Staff Report

Site Plan Review – New Construction

SP-18-23

PROPOSED SITE PLAN
 EYECARE ASSOCIATES
 MEDICAL OFFICE
 ALBANY, OR

Sheet **C103B**

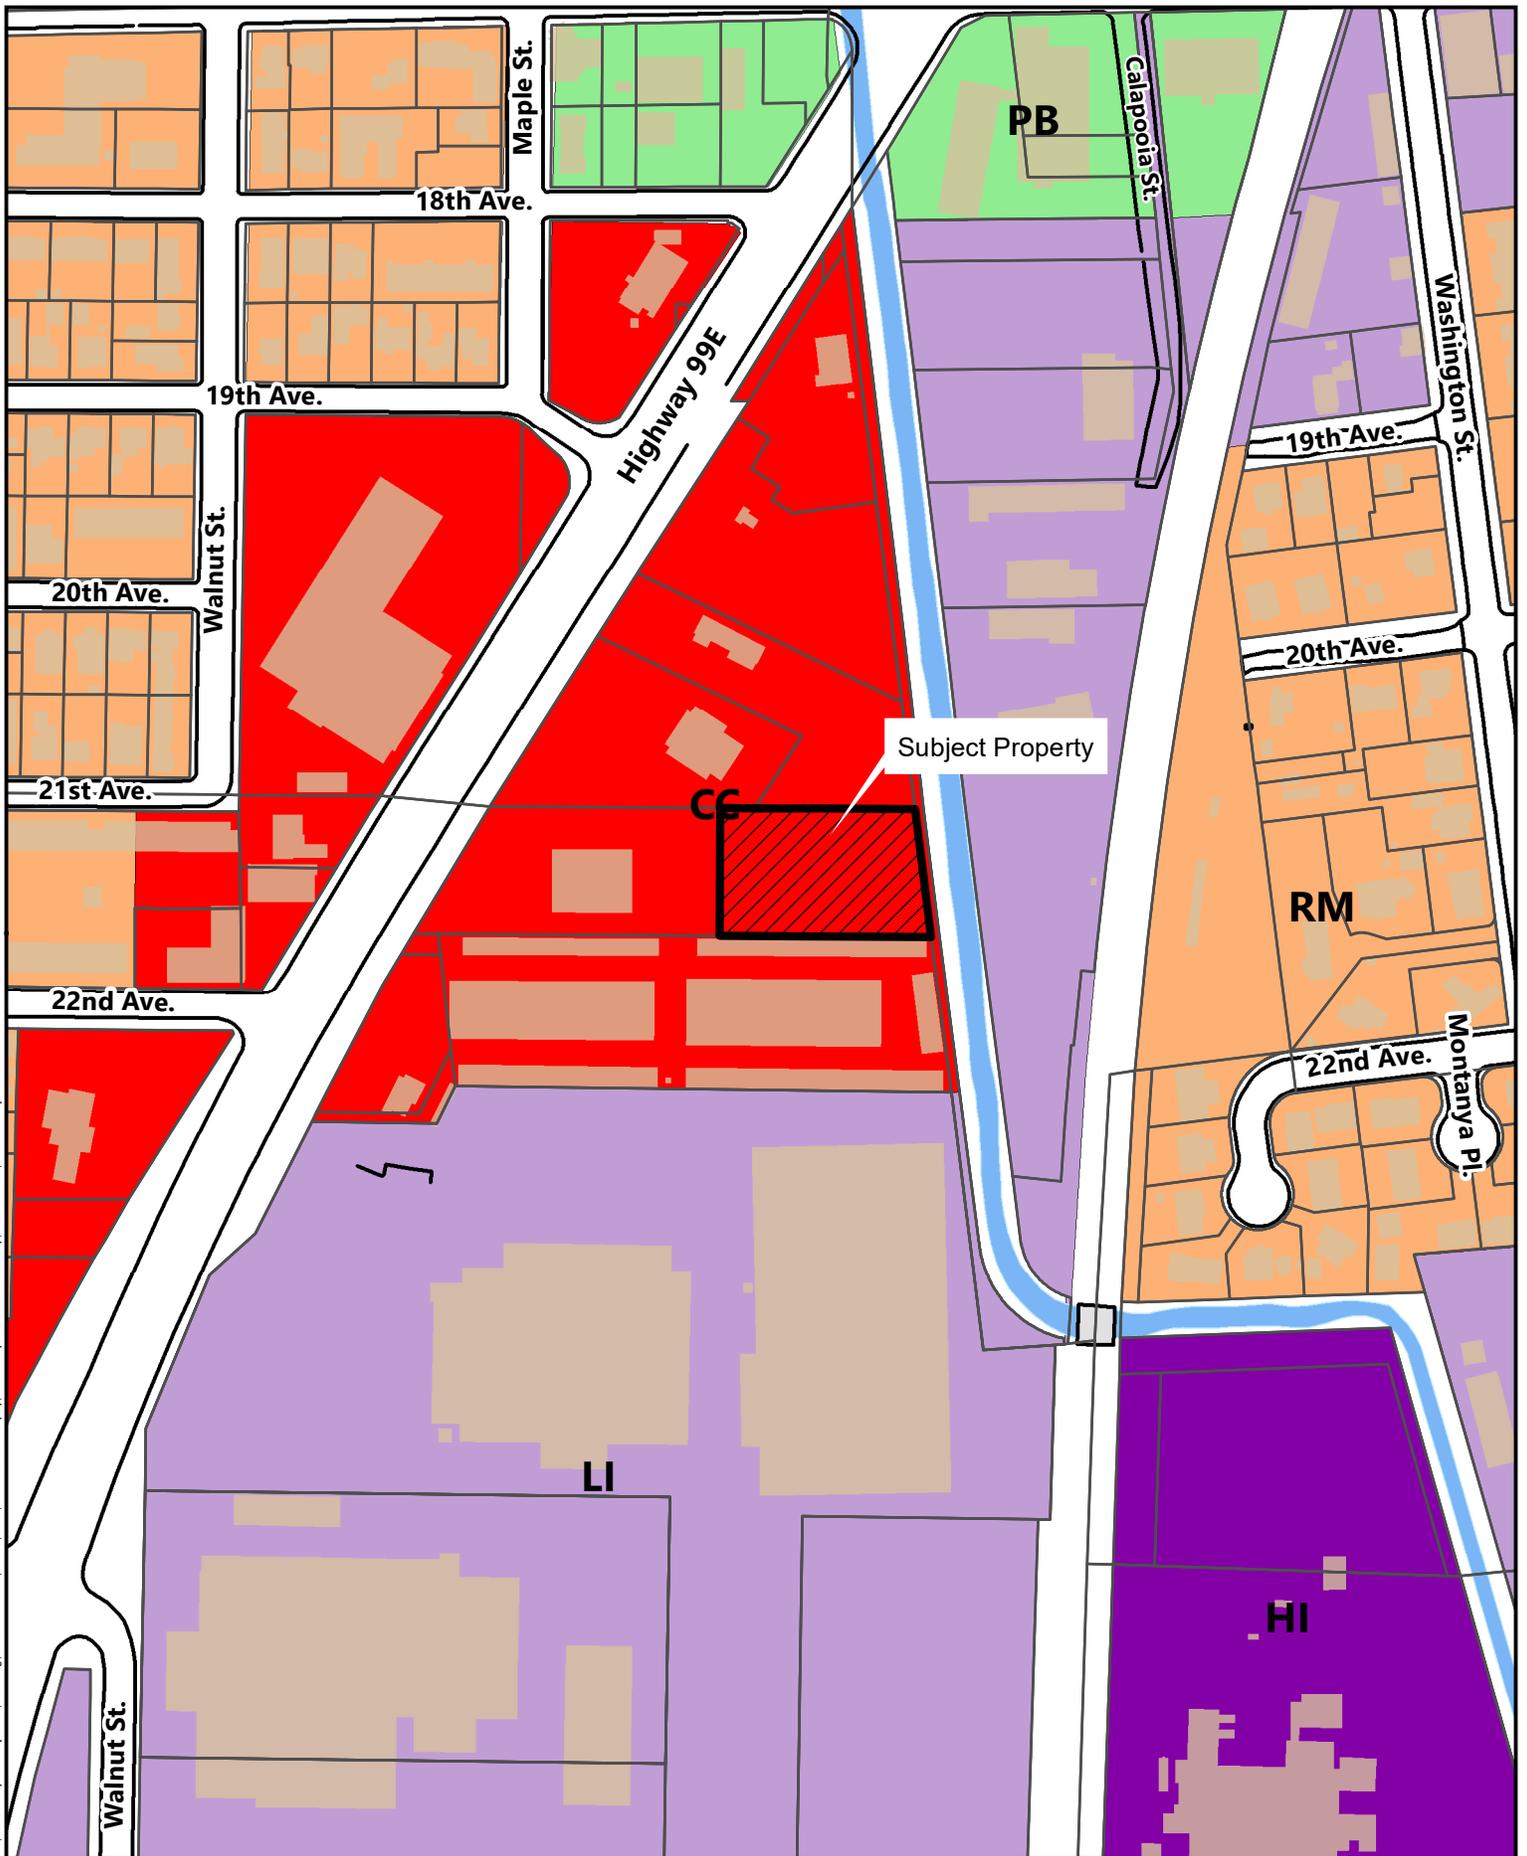
The submitted site plan (Attachment B) indicates a refuse container area southwest of the proposed structure. The refuse container is not located within 15 feet of any dwelling window or within a required setback area. The refuse container area will be screened with a six-foot-tall sight obscuring fence, complying with the standards of ADC 5.370. This standard is met.

- 7.7 The City of Albany's access gate is located at the southeast corner of the property. This access will be blocked by the building and shall be relocated to the northeast corner of the site.

- Condition 10** Prior to building permit issuance, the applicant must vacate the existing 25-foot access easement (Vol. 160 Pg. 327) along the south property line as shown on the submitted site plan, Attachment B. A copy of the vacated easement must be submitted to the Community Development Department prior to building permit issuance.

- Condition 7 Access.** The applicant shall relocate the City of Albany's canal access gate to the northeast corner of the site and provide 15-foot-wide access easement to the canal.

- Condition 10 Vacation of Easement.** Prior to building permit issuance, the applicant must vacate the existing 25-foot access easement (Vol. 160 Pg. 327) along the south property line as shown on the submitted site plan. A copy of the vacated easement must be submitted to the Community Development Department prior to building permit issuance.
